Lantabur Apparels Ltd Taqwa Fabrics Ltd & Libas Knitwear.

4th November, 2015

Observations

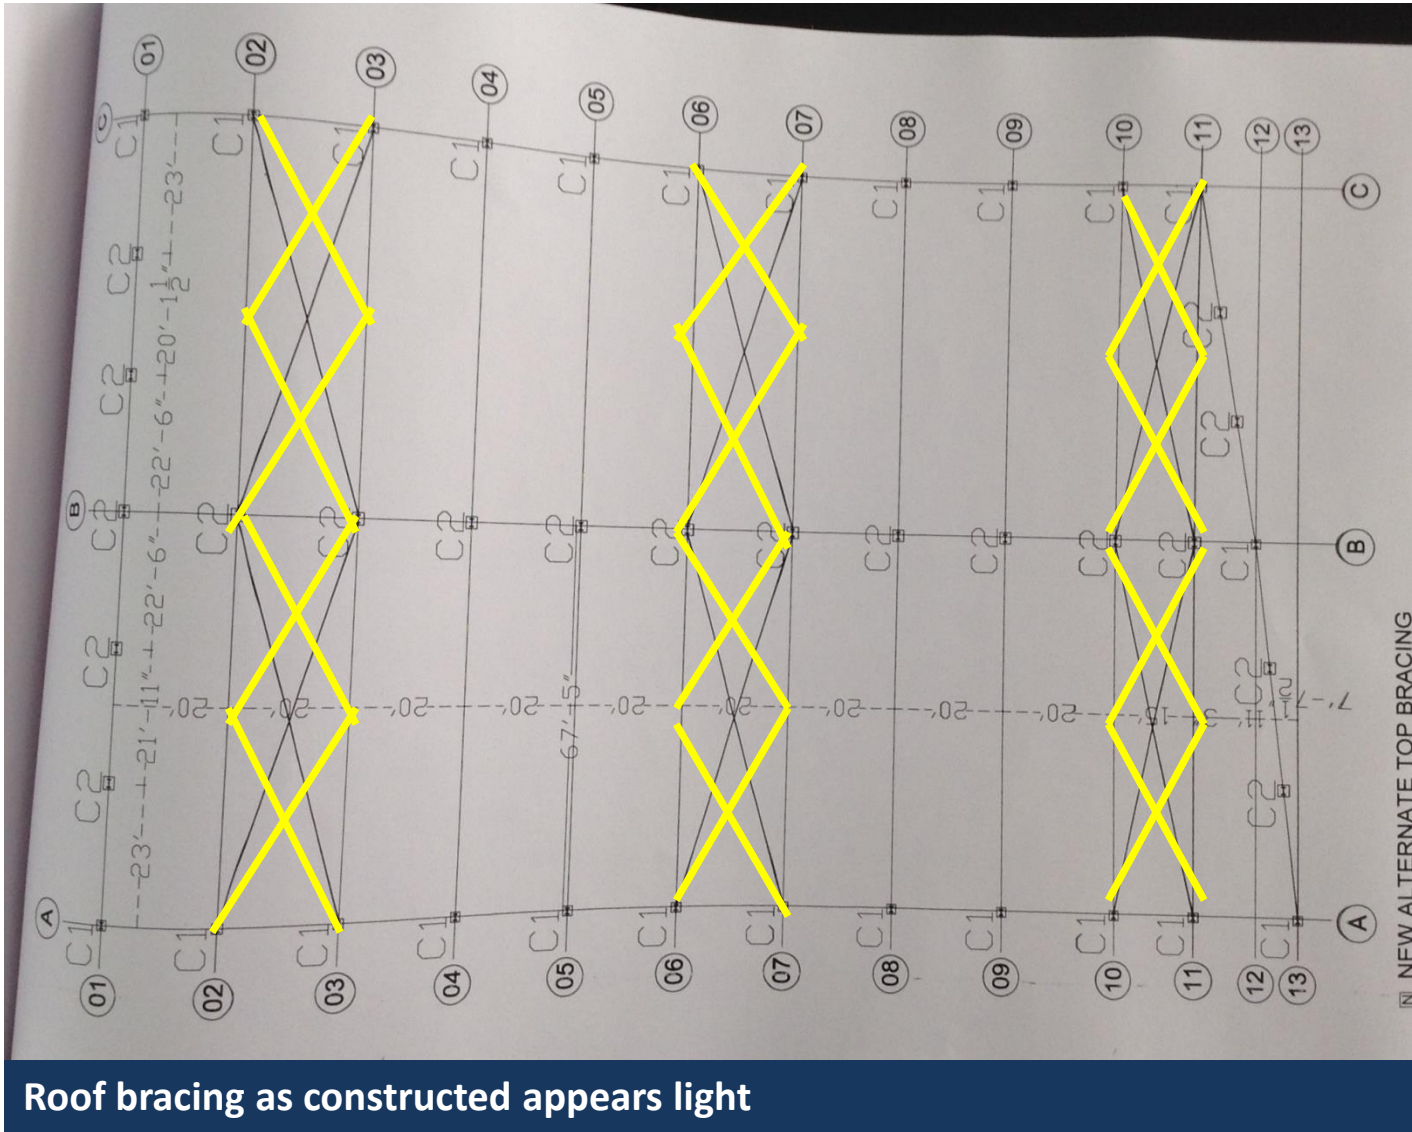
Missing bottom flange plates to rafter splices portal 02

Gable masonry wall has no head restraint

Roof bracing as constructed appears light

Item No.	Observation	Recommended Action Plan	Recommended Timeline
26	Shed 2 Open moment joint in portal 10	Engineer to review the joint as-built on site and propose remedial works	6-weeks
27	Shed 2 Open moment joint in portal 10	Carry out the remedial works from the above study	6-months
28	Shed 2 Missing bottom flange plates to rafter splices portal 02	Engineer to review the splice connections and propose remedial work to correct the splice joint	6-weeks
29	Shed 2 Missing bottom flange plates to rafter splices portal 02	Carry out the remedial works from the above study	6-months
30	Shed 2 Gable masonry wall has no head restraint	Engineer to review the capacity of the wall panels without head restraint to resist lateral loading and make suitable recommendations on remedial works	6-weeks
31	Shed 2 Gable masonry wall has no head restraint	Carry out the remedial works from the above study	6-months

Item No.	Observation	Recommended Action Plan	Recommended Timeline
32	<p style="text-align: center;">Shed 2</p> <p>Roof bracing as constructed not as shown on drawings. (appears light)</p>	<p>Engineer to review the as-built roof bracing by calculation to resist lateral loading to the gable.</p>	<p style="text-align: center;">6-weeks</p>
33	<p style="text-align: center;">Shed 2</p> <p>Roof bracing as constructed not as shown on drawings. (appears light)</p>	<p>Update drawing to show as built</p>	<p style="text-align: center;">6-weeks</p>
34	<p style="text-align: center;">Shed 2</p> <p>Roof bracing as constructed not as shown on drawings. (appears light)</p>	<p>Carry out the remedial works from the above study</p>	<p style="text-align: center;">6-months</p>
